Access Compliance Report

Public Rights-of-Way

Intersection ID: 48557	Main Street: RIDGEFOREST_DR	Cross Street: ARDREY_WOODS_DR	Location: SE
ADA ID: 44B5C97BDA81	Ramp Type: BlendTrans1	Initial Pass/Fail: Pass	Overall Compliance: No
Severity Score: 5			
Codes/Mitigation Info/Possible Solution		Field Measurements/Component Compliance

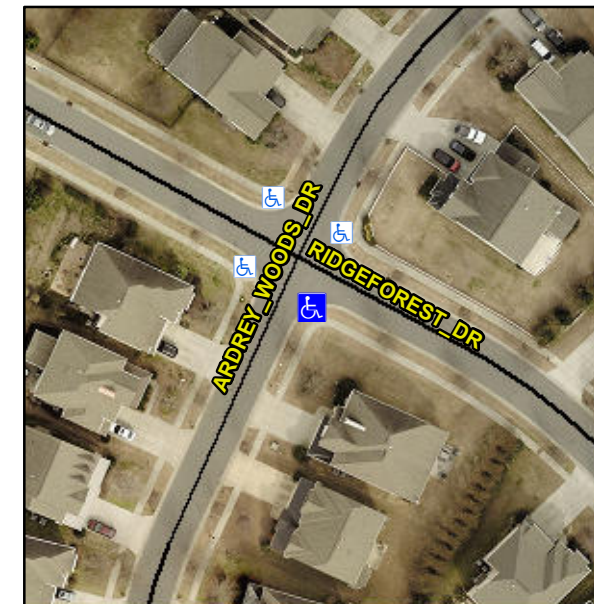
Not Found, R304.2.1, R304.5.4

N/A	Ramp inside XWalk1?	N/A	N/A	Ramp inside XWalk2?	N/A
	Road Slope (%)	0.0		Clear Space?	Yes
	Road X Slope (%)	3.0	N/A	Clear Space to XWalk (in)	N/A
Yes	Any Obstructions?	No	Yes	Storm Grate/Utility Hazard?	No
	Obstruction Type			Storm Grate/Utility Type	
		N/A			N/A
			Yes	Surface Condition? (G/P)	Good
			No	Curb Slope (%)	12.2

Remove & Replace Curb Ramp With Two New Directional Ramps or Equivalent. Remove & Replace Gutter.
